## OLIVE GARDEN FAÇADE UPDATE JSP13-05

### Olive Garden Façade Update, JSP13-05

## PLAN REVIEW CENTER REPORT

Preliminary/Final Site Plan  
Olive Garden Façade Update  
JSP 13-05

OPTION TWO - OLIVE GARDEN - #1330  
Novi, MI

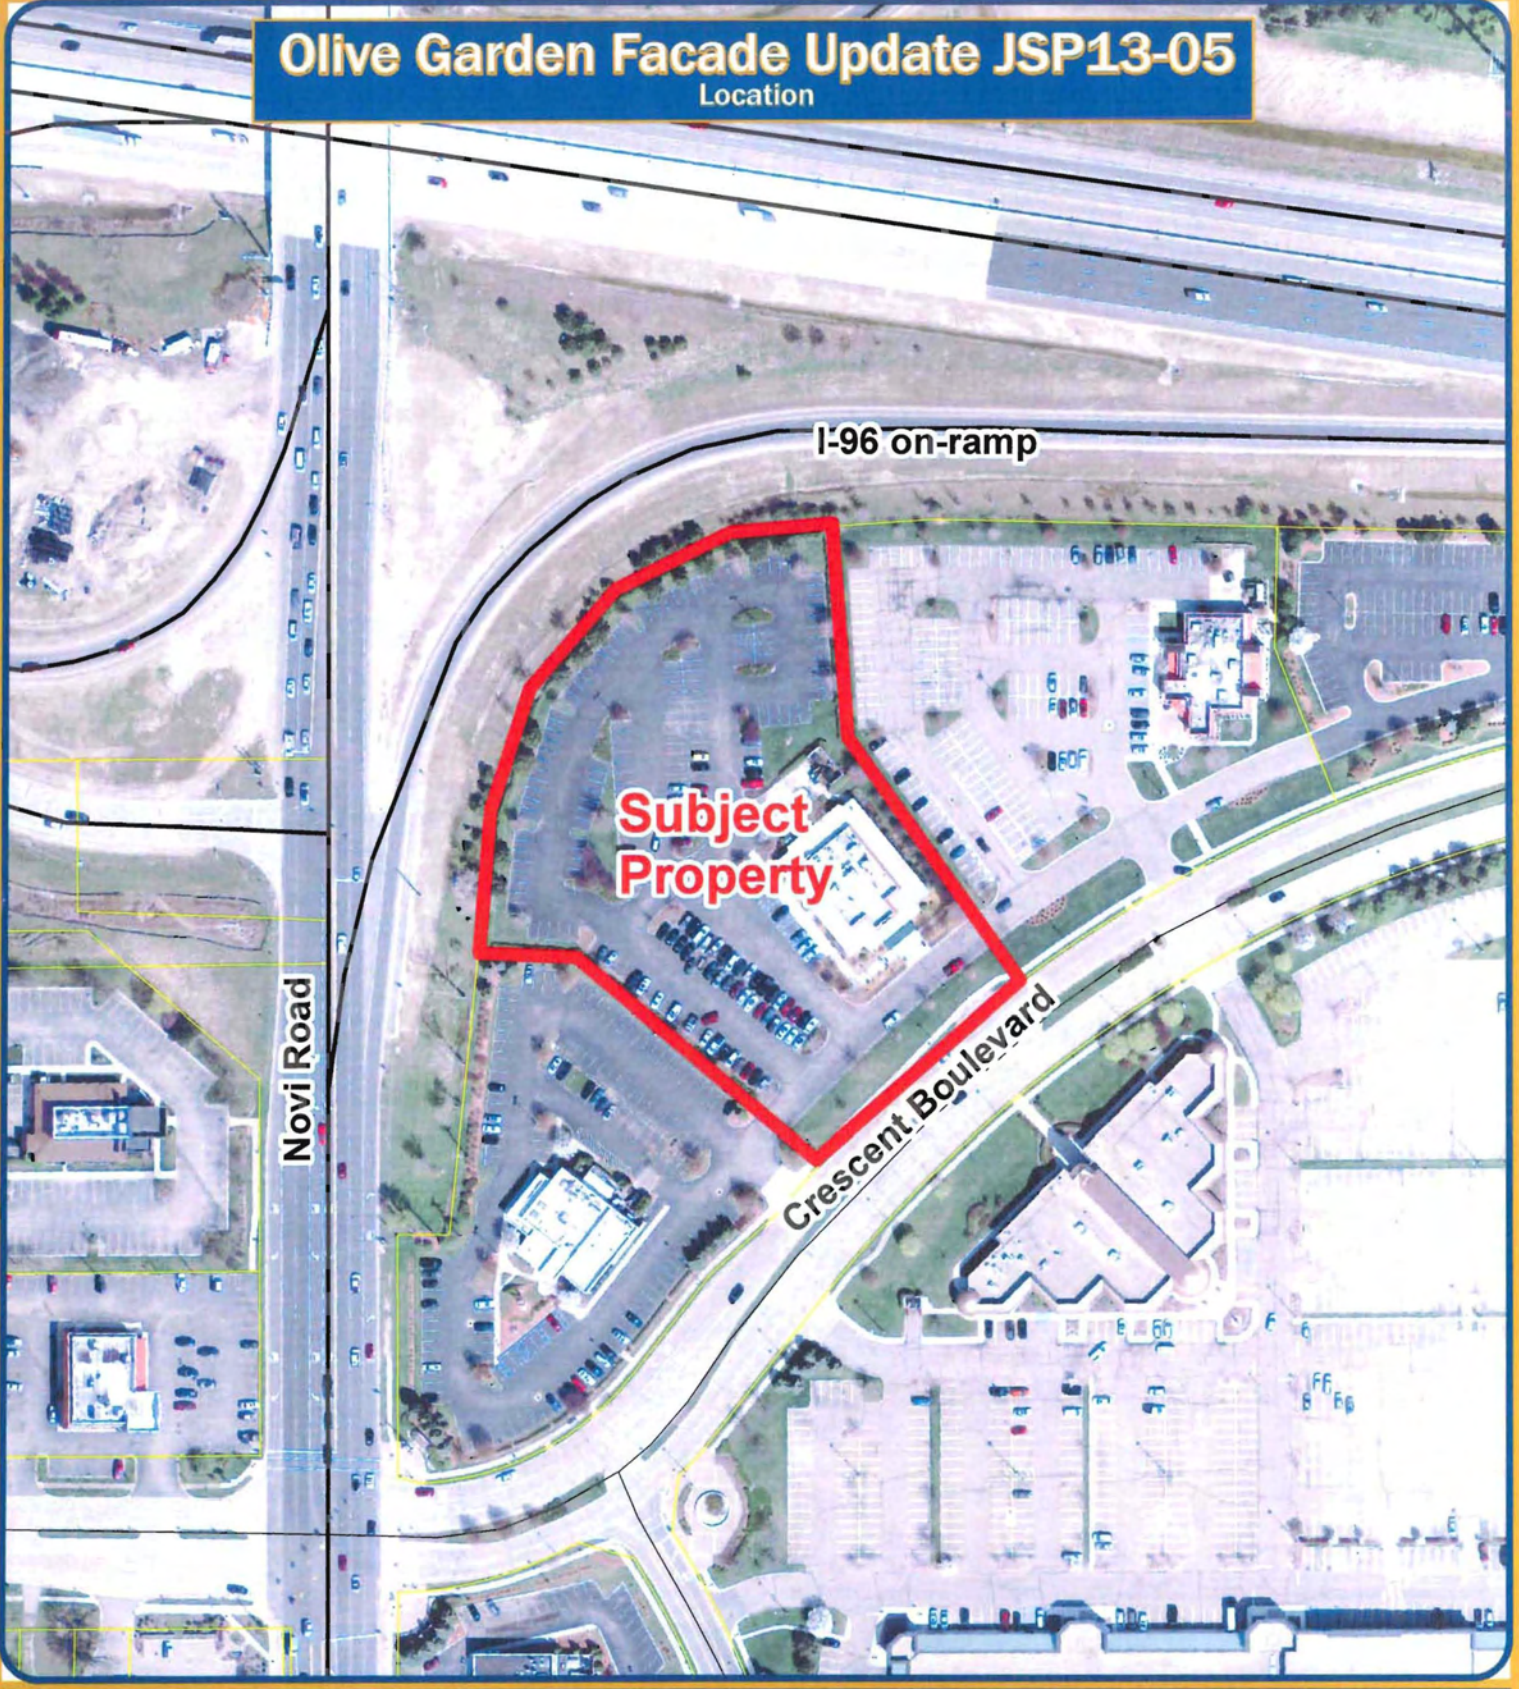
Comment 1: The entrance feature shall be composed of brick and stone in lieu of the proposed EIFS. A material sample board shall be submitted prior to the Planning Commission meeting per the façade review letter.

Response 1: *Understood, will comply. Please see attached colored rendering reflecting the proposed elevations with brick over the entire entrance feature as requested. If the rendering is approved by the Planning Commission, we will revise our plans to reflect these changes as required.*

*Please see attached exterior paint color specifications reflecting the proposed Benjamin Moore colors at the exterior listed below (also reflected on the colored renderings).*

- *BM 303 Old World Romance (applied to existing and new trim).*
- *BM HC-67 Clinton Brown (applied to all gutters, downspouts, fascia and service doors)*
- *BM 2142-10 Mediterranean Olive (applied to existing trellis system)*
- *Please note that the new brick finish at the entrance feature is to match the existing brick finish color and style in order to stay consistent with what is existing.*
